Access Compliance Report Public Rights-of-Way (Curb Ramps)

Main Street: CHARLOMA_DR Cross Street: WASS_ST Location: NW

ADA ID: RPAT211011102408 Ramp Type: Type 1 - Perpendicular Diagonal Initial Pass/Fail: Fail Overall Compliance: No Severity Score: 30

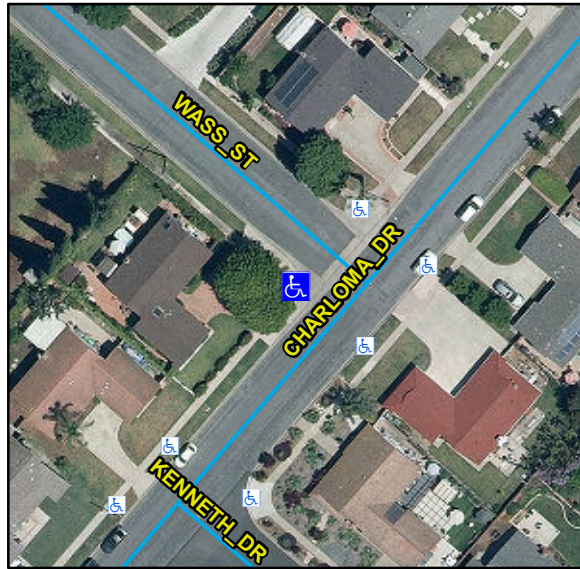
Compliance	Description	Data	Compliance	Description	Data
N/A	Ramp Length (in)	132	N/A	Flare Type LT	
Yes	Ramp Width (in)	57			N/A
Yes	Ramp Run Slope (%)	7.9	N/A	Flare Slope LT (%)	N/A
No	Ramp Cross Slope (%)	8.5	N/A	Flare Traversable LT	N/A
N/A	Landing Present	N/A	N/A	Flare Type RT	
N/A	Landing Length (in)	N/A			N/A
N/A	Landing Width (in)	N/A	N/A	Flare Slope RT (%)	N/A
N/A	Landing Run Slope (%)	N/A	N/A	Flare Traversable RT	N/A
N/A	Landing Cross Slope (%)	N/A	N/A	DWS Provided	N/A
N/A	Landing Movement Obstructed?	N/A	N/A	DWS Contrast	N/A
	Landing Movement Type	N/A	N/A	DWS Length (in)	N/A
N/A	Landing Shared	N/A	N/A	DWS Full Width	N/A
N/A	Clear Space	Yes	N/A	DWS Offset Left (in)	N/A
N/A	Clear Space To Crosswalk (in)	N/A	N/A	DWS Offset Right (in)	N/A
N/A	Marked Crosswalk 1	No	N/A	Marked Crosswalk 2	No
	Crossing 1 Direction	SE		Crossing 2 Direction	NE
	Marked Crosswalk 1 Width (in)	N/A		Marked Crosswalk 2 Width (in)	N/A

N/A	Ramp Inside Crosswalk 1	N/A	Yes	Ramp Inside Crosswalk 2	N/A
	Crossing 1 Slope (%)	2.7		Crossing 2 Slope (%)	5.2
	Crossing 1 Cross Slope (%)	3.4		Crossing 2 Cross Slope (%)	8.2
N/A	Gutter Ponding	N/A	No	Curb Slope	6
Yes	Gutter Lip Height (in)	0		Road Run Slope (%)	2.4
N/A	Gutter Run Slope (%)	N/A		Road Cross Slope (%)	6
N/A	Gutter Cross Slope (%)	N/A			
Yes	Overall Surface Condition: Acceptable		Yes	Perp Joint Present	Yes
	Cross Gutter Present?	Yes		Spandrel Present?	Yes
	Replace Cross Gutter?	No		Replace Spandrel?	No

Remove & Replace Curb Ramp With Two New Directional Ramps or Equivalent.
